RESPONSE TO AUDIT ISSUES

APR1400 Topical Reports

Review Section	TR Realistic Evaluation Methodology for LBLOCA of the APR1400
Application Section	Topical Report: APR1400-F-A-TR-12004 Realistic Evaluation Methodology for Large-Break LOCA of the APR1400
Issue Date	08/13/2015

Audit Issues No. 20

Figure 1. Total Nitrogen Gas Release Rate from Four SIT-FDs

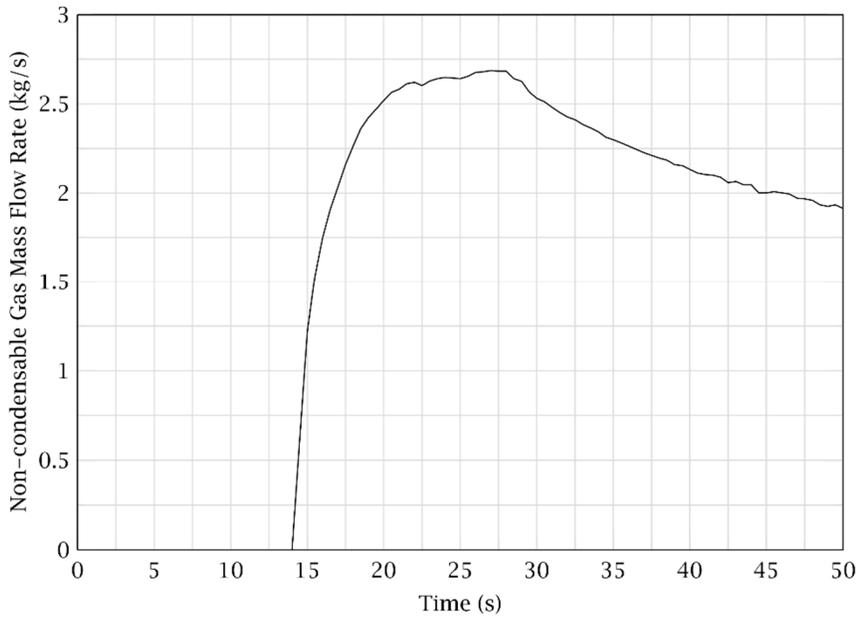
The guidance in RG 1.157, Section 2.1.2 establishes acceptable controls for the calculation of the effects of noncondensable gases in best estimate analysis. In addition, NUREG/CR-5249 (pg. 68) explicitly addresses the bias due to dissolved nitrogen. The RELAP5/MOD3.3 code does not model dissolved nitrogen in the liquid and therefore, the predicted reflood peak cladding temperature does not reflect its effect. An assessment and documentation of the effect of dissolved nitrogen on the PCT is needed.

Figure 1 shows the total dissolved nitrogen gas release rate from four SIT-FDs. The peak mass flow rate of dissolved nitrogen is about 2.7 kg/s, and this value exceeds the maximum value of Reference [1] as described above. This is intended to demonstrate the apparent effect of dissolved nitrogen on ECCW bypass.
